Responses to AIR Data Requests – Nos. 12 through 42

Amended Application for Certification for HYDROGEN ENERGY CALIFORNIA (08-AFC-8A) Kern County, California

**RESPONSES TO DATA REQUESTS 12 THROUGH 42
FROM THE ASSOCIATION OF IRRITATED RESIDENTS (AIR)**

ad:\gis\HECA\Project\HECA 2012\Data Request 2012\Fig20-1 Existing LandUse.mxd 11/26/2012 8:48:41 AM

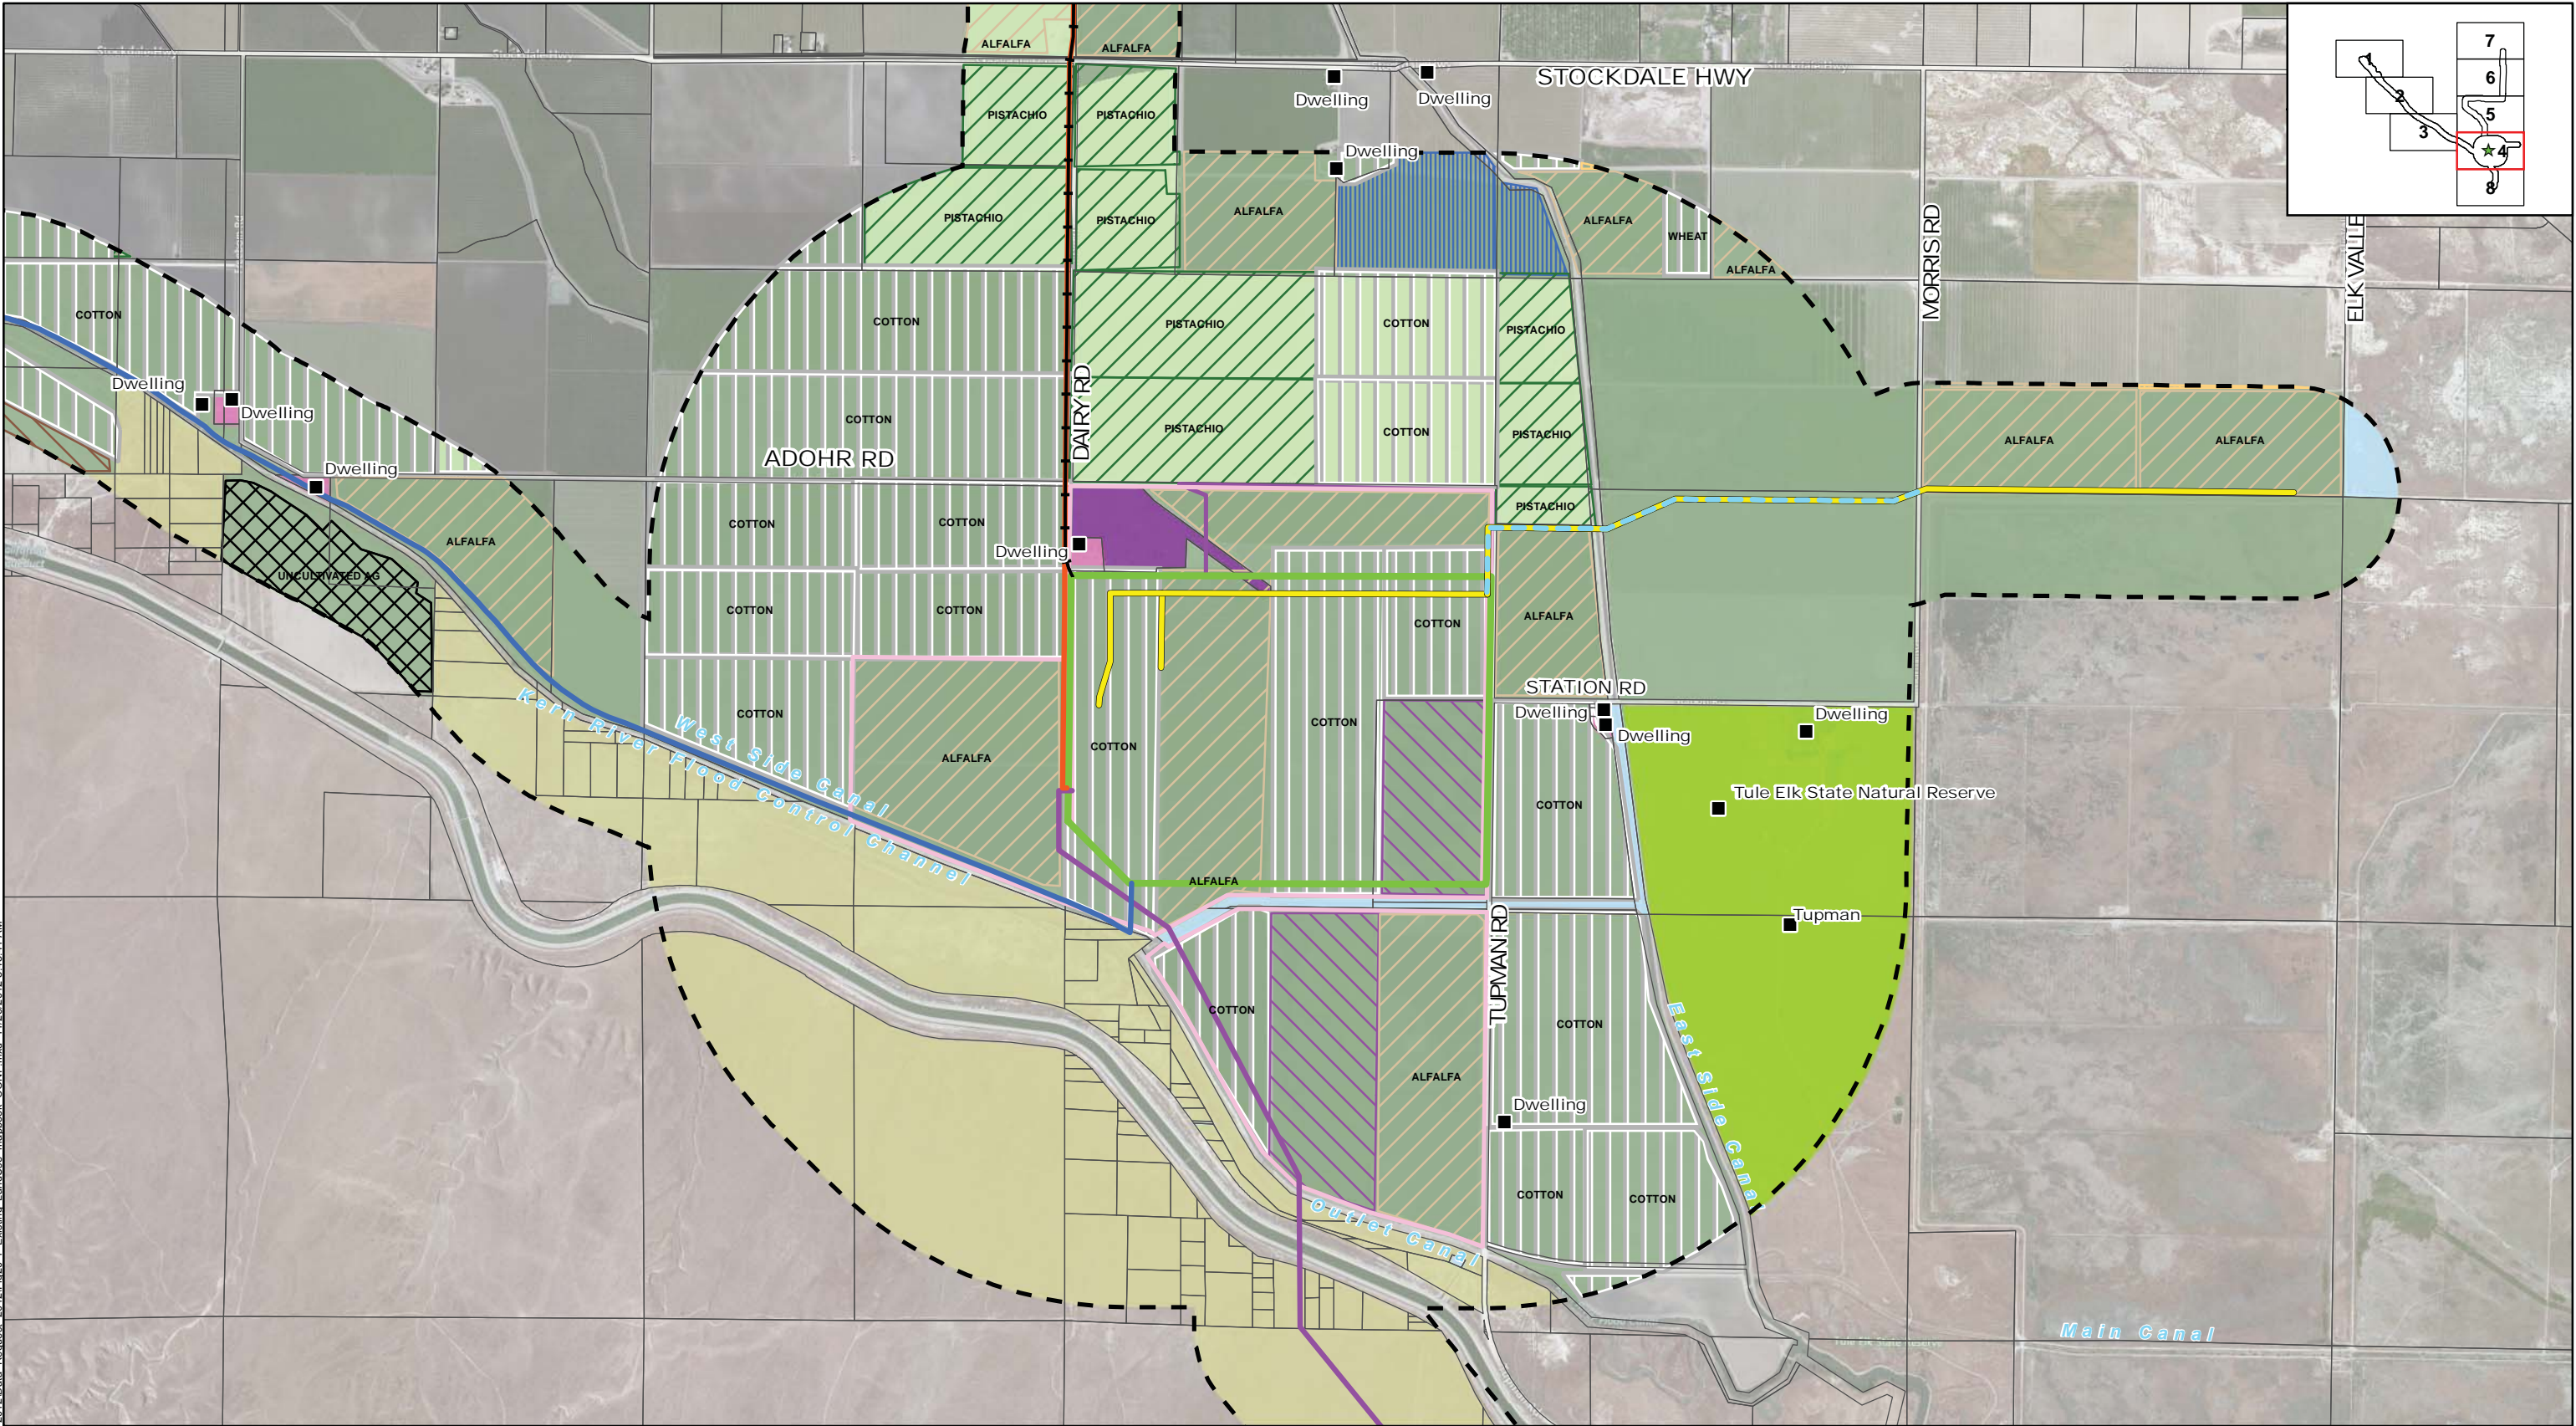
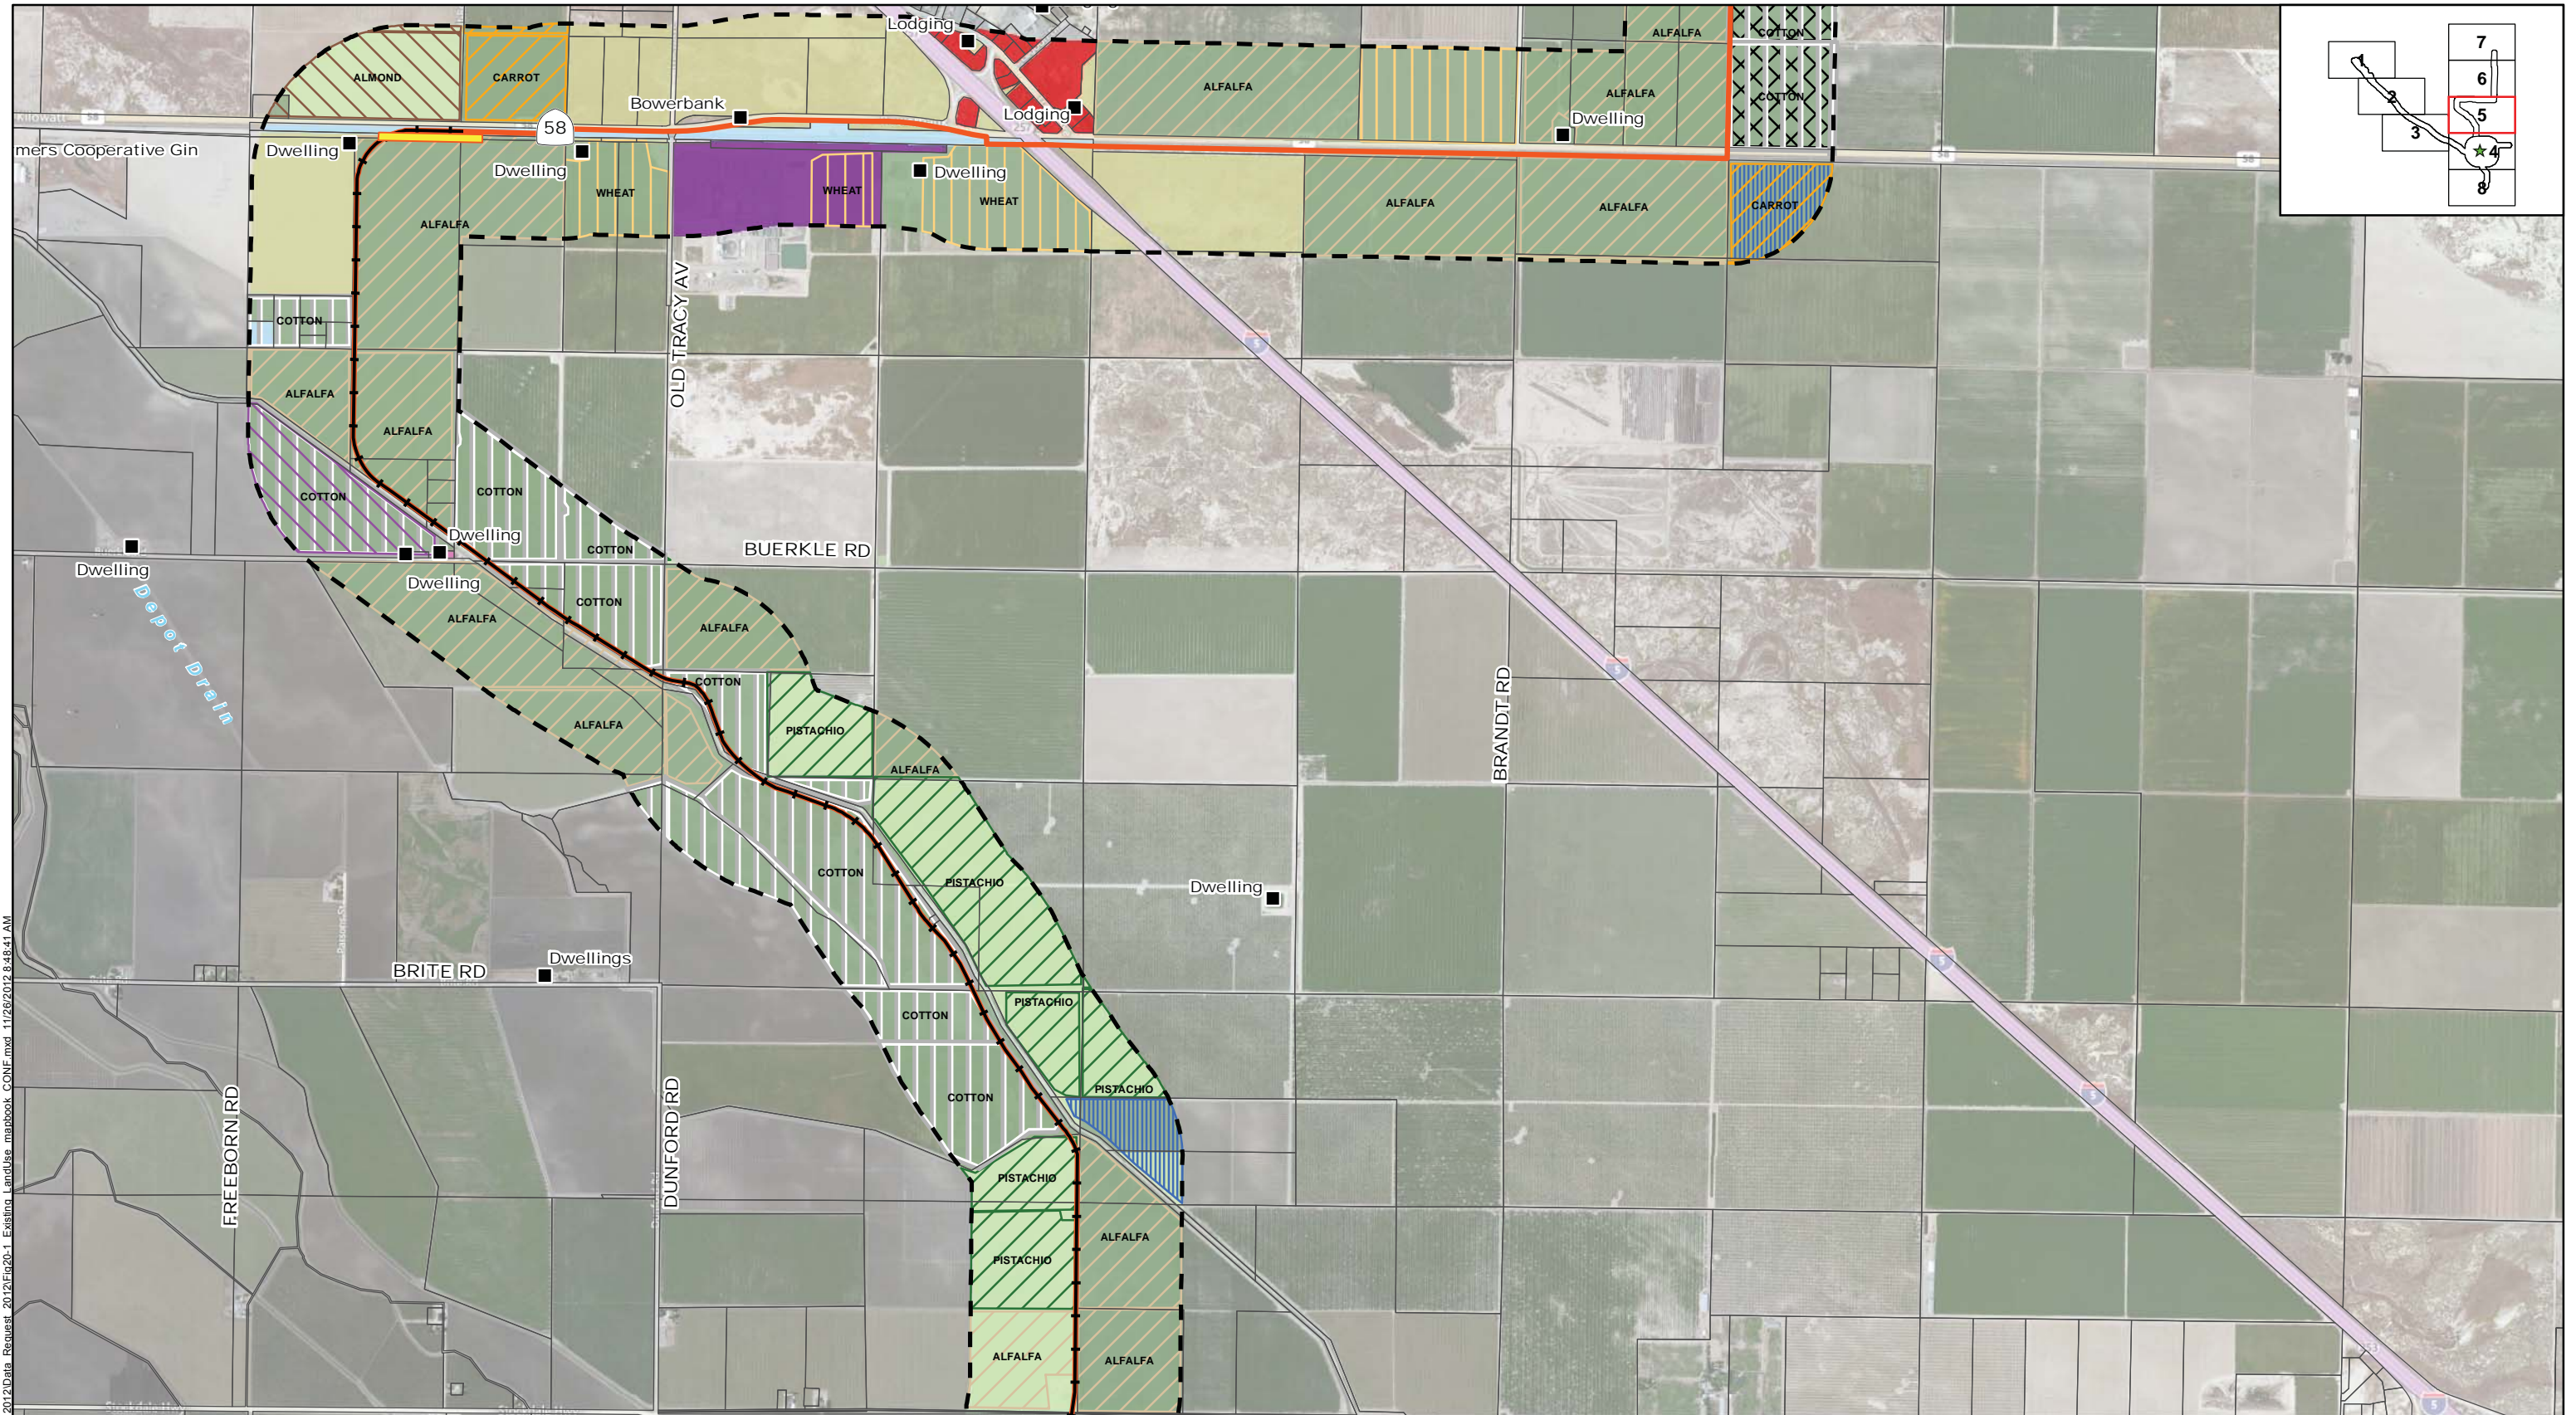
- (2) Where will the railroad spur be located? Please provide a map with details of the exact right of way needed so that each affected land owner will know exactly what is proposed on their respective properties.**

2. Figures showing the location of the railroad spur were previously provided to the CEC under confidential cover in May 2012. For reference and since the route is no longer confidential, the figures showing the location of the railroad spur and the land uses along the route are attached to this document as Figures 20-1 Sheets 1 through 8.
3. As indicated in the response to AIR Data Requests 1 and 2, as a private entity, HECA does not have the power of eminent domain. Thus, there are no plans to acquire any property or rights of way needed for the Project by eminent domain.
4. The exact route staff will travel to the Site will depend upon their point of origin but in general staff will travel from Stockdale Highway to Dairy Road and into the plant via the entrance off of Dairy Road. Alternatively, staff will travel via the truck route described in the response to Data Request 24 (3).
